COMMENT RESPONSE DOCUMENT

EASA PAD No. 21-013

[Published on 02 February 2021 and officially closed for comments on 02 March 2021]

HPT Case with cast ports (brazed/welded) – item is tracked by HPT Case S/N.

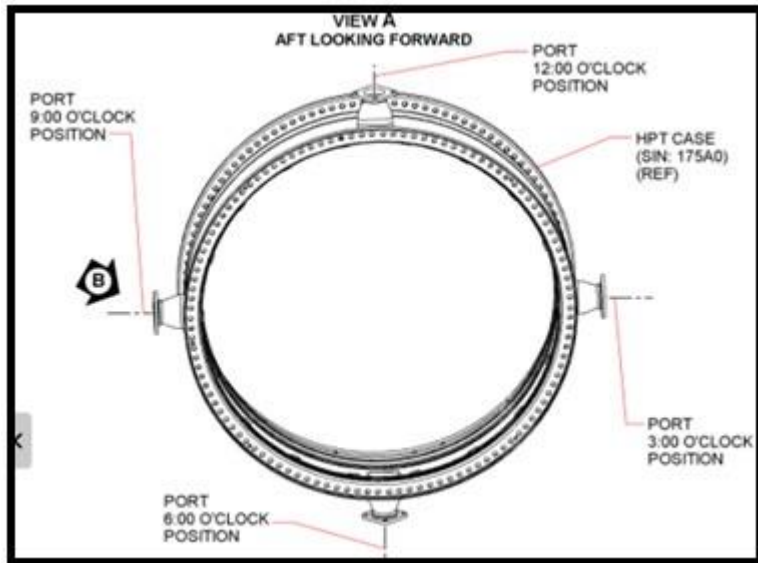
By providing only the Port Serial Numbers, the tracking of affected components is significantly impaired, especially when the HPT Case (which is the tracked item) is not identified. Of note, given there are a maximum of 8 HPT Cases affected by this issue, the small population should be easily identifiable (as per the data being collected by CFM at this time).

BAW would strongly recommend that the AD identifies the affected HPT Case Ports AND their parent HPT Case serial number (tracked item), to ensure parts can be more easily identified on the records usually provided with an engine (i.e. the tracked/life limited parts list).

Port serial numbers are not identified on the records provided to operators.

Comment noted. EASA agrees. EASA has communicated this comment to CFM and requested CFM to use the information collected with SB LEAP-1A-72-00-0417-01A-930A-D for future updates of LEAP-1A-72-00-0421-01A-930A-D in order to facilitate the identification of the affected HPT cases. CFM also confirmed that HPT cases not listed in LEAP-1A-72-00-0417-01A-930A-D are assured to not contain an affected port casting. This information is used to amend the definition of a serviceable HPT case in the final AD.
